Re: Re-zoning and Development Permit Application: 1400 Fairfield Road and 349/351 Kipling Street
(Rez No. 00702 & DP No. 000555)

Appendix A: Summary of Plan Revisions – Direct Responses to the Application Review Summary (Received November 19, 2021 from July 30, 2021 Re-submission)

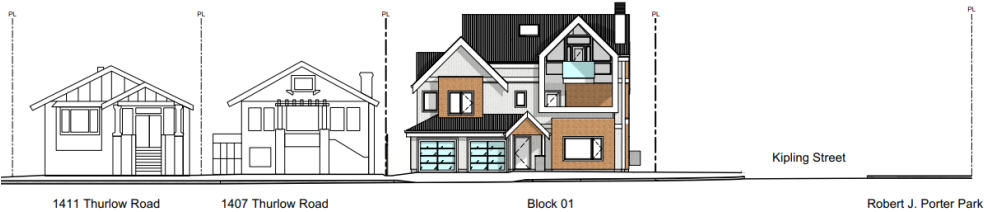
Condition #14: The location and species of the four bylaw replacement trees is supported. Two of the other onsite trees are shown directly over underground servicing. Please review their proposed location to ensure that they can be planted.

- One on-site tree was found to be in conflict with utilities (adjacent to the Unit 1 driveway) and was removed and replaced with a rhododendron. There is one less tree proposed on the site.

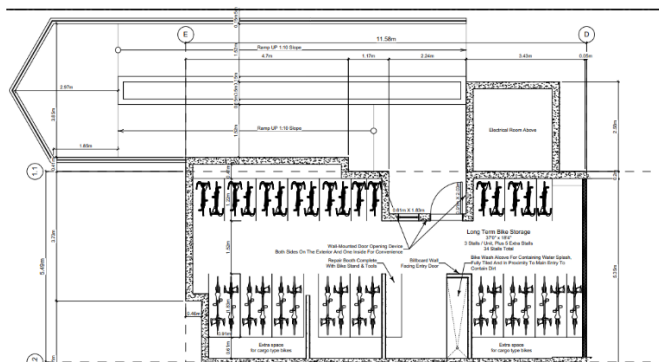
<p>Motion 4: provide a more sensitive transition with adjacent properties</p>	<p>As mentioned in the response to motion 1, heights of the clusters have decreased, across the site.</p> <p>The façade fronting Thurlow Rd. was revised to present as a single family dwelling to further integrate with existing form and character. The building steps down to reduce the height transition between the neighbouring buildings on Thurlow Rd. See below a revised image of the Thurlow Rd. Façade:</p>  <p>Peaked roofs and traditional materials were incorporated into the revised design to better align with the form and character of the area. Below is an illustration of the streetscape on the Fairfield Rd. Façade, showing the transition from single family homes to two of the units (unit 8,9), which present as a two-storey duplex.</p>  <p>Significant effort has also been made to limit overlook in the redesign. Rear yard outdoor space is now provided near natural grade level (as opposed to a roofdeck), and top floor windows are primarily placed high in rooms (providing light, but not overlook).</p>

<p>Motion 5: ensure the form and character of the development is compatible with the predominant neighbourhood character, consistent with the Design Guidelines for Development Permit Area 15F: Intensive Residential– Attached Dwellings”</p>	<p>Several actions have been taken to ensure form and character compatibility. The revised submission now includes the following design elements:</p> <ul style="list-style-type: none"> • Traditional architectural features such as a chimney, wood soffits, and peaked rooflines; • Bay windows and “punch” traditional windows; • Traditional cladding, which includes wood soffits, vertical wood siding, and wood shingles; • Front Porches on Fairfield Rd. and Thurlow Rd. Facades; • Reduced hardscape through clustered parking; • Landscaped front and rear yards; • Limited upper level rear windows to reduce overlook; • A single-family house looking façade along Thurlow Rd., which is currently comprised of primarily single-family homes. <p>See below a side by side comparison between past versions illustrating the change in form and character:</p>
